Please find attached submission related to MOD2022/0630 – DA2021/2257 – 42 North Steyne & 75 The Corso.

SUBMISSION: MOD2022/0630 - DA2021/2257; Lot 1 DP 1034722 and Lot 100, Lot 101 & Lot 102 DP 1069144 42
North Steyne and 75 The Corso MANLY

Image 1: Plans – Master Set, page 5

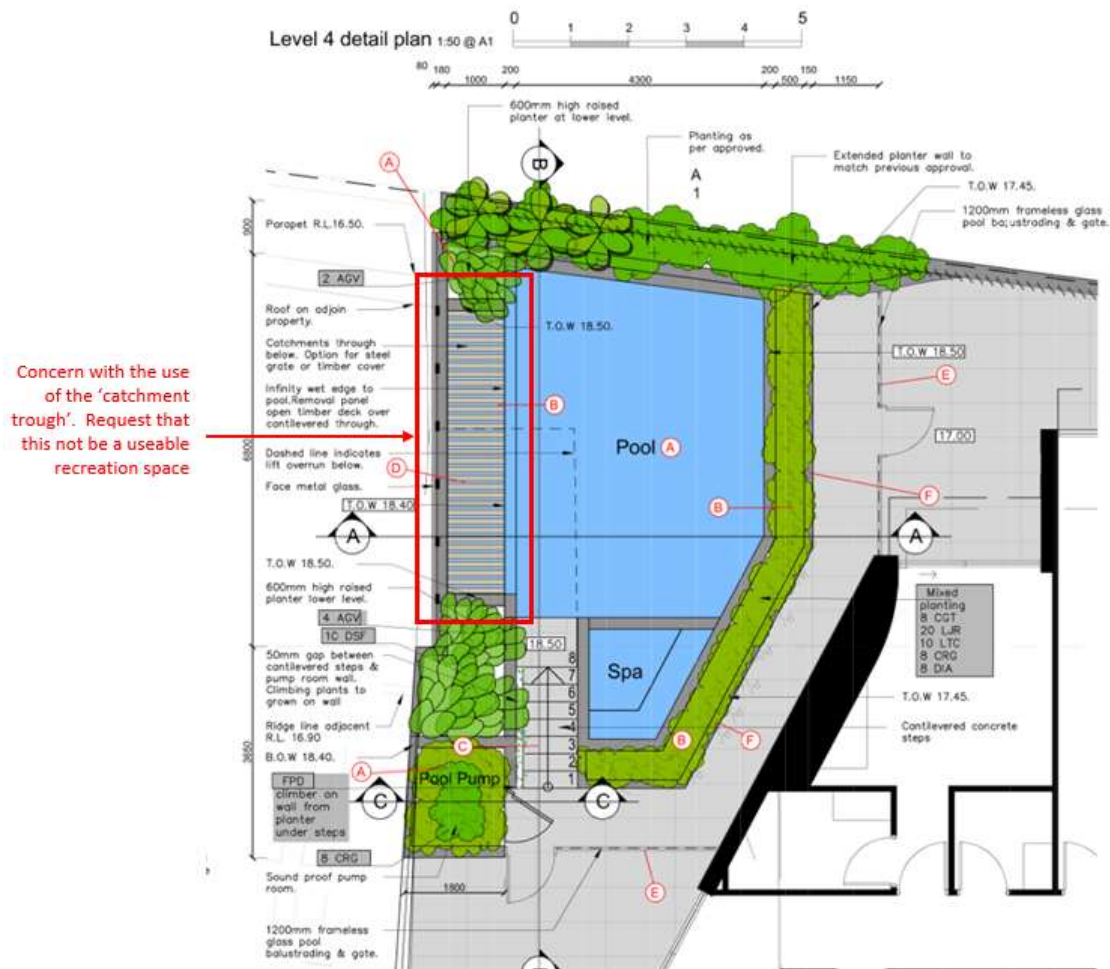
Pool Catchment trough: Request that the pool catchment trough be only a 'catchment trough' and not to be used as a raised seating decked area. Use of this area for any recreational purposes including furniture and parasols would go against the reasoning for L&EC - DA2021/2257 redesign which ensures that the view corridor from Pacific Waves unit 505 and other units are continuously protected. We request that the 'catchment trough' be designed and that a consent condition be added to any approval that the 'catchment trough' area cannot be used for any

recreational use; it must be a non-trafficable area. Area of concern highlighted by red rectangle in the below image 1 taken from 'Plans_-_Master_Set', page 5.

Compliance with previously approved plans for boundary adjoining 75 The Corso: We believe that by ensuring the 'catchment trough' is non-recreational, the safety issues of proximity to the boundary wall are addressed. To note, the boundary wall is approved to be acoustic glass no higher than 1.8m. Any proposed increase in height would breach the view corridor protection and previously approved design.

Image 3: Plans – Master Set, page 5

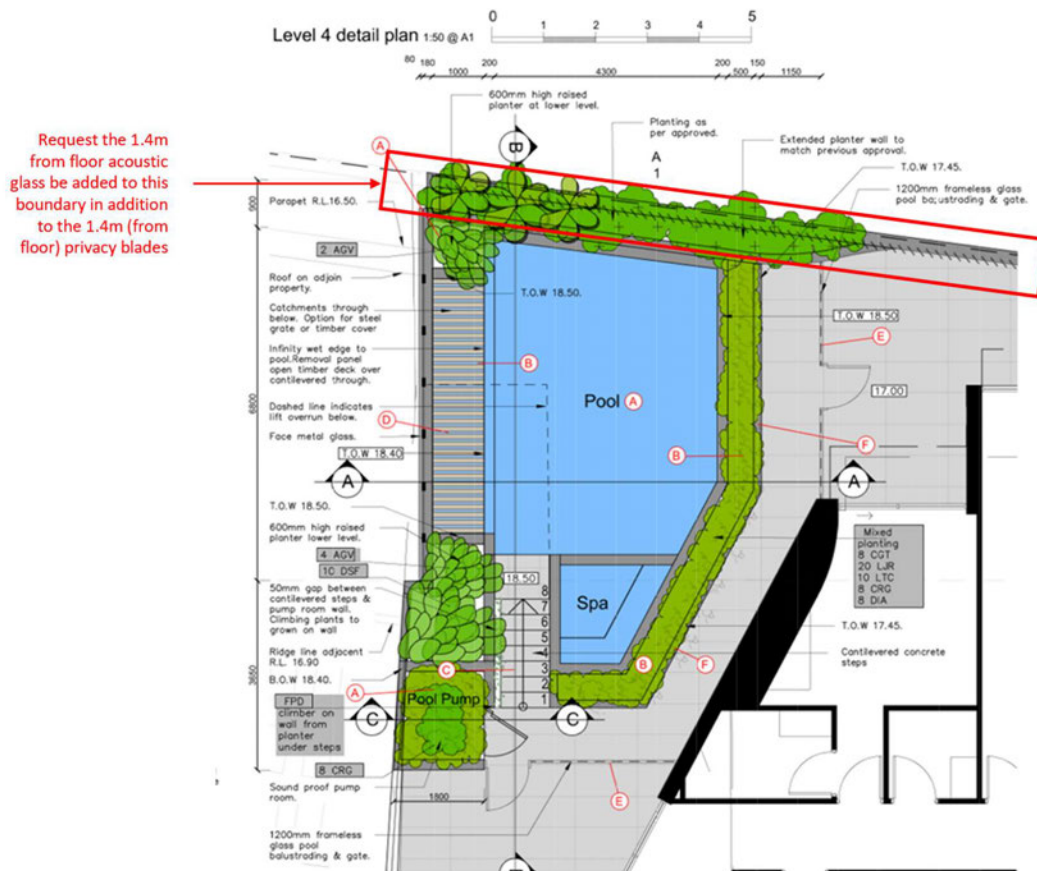
Noise Concerns: We are extremely concerned about the potential noise that will emanate from pool use, especially from children and pool parties. We request that without increasing boundary heights which would impact view corridors, further acoustic protection is added to the development to protect neighboring residences. Request for a condition to be added that: 1.4m acoustic glass (in addition to the 1.4m privacy blades) to be installed on the Henrietta Lane boundary. Noting that 1.8m high acoustic glass is already being used along the boundary to 75 The Corso (The Steyne Hotel and its courtyard). Boundary highlighted by red rectangle in the below image 3 taken from 'Plans - Master_Set', page 5.
